Remote Link and System Link Software Update

August 2005

Version 1.25 Software Update

Operator Password

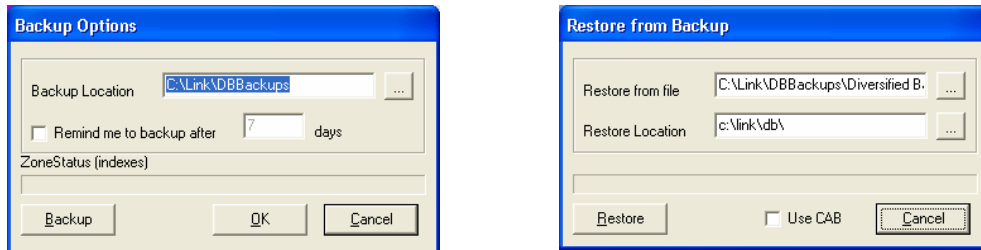
Previously, the characters of the operator password would be displayed in clear text instead of asterisks, and a separate pop-up window was used for validation.

When entering a new Remote Link operator, Remote Link now displays the operator password as asterisks when entered in the password validation field.
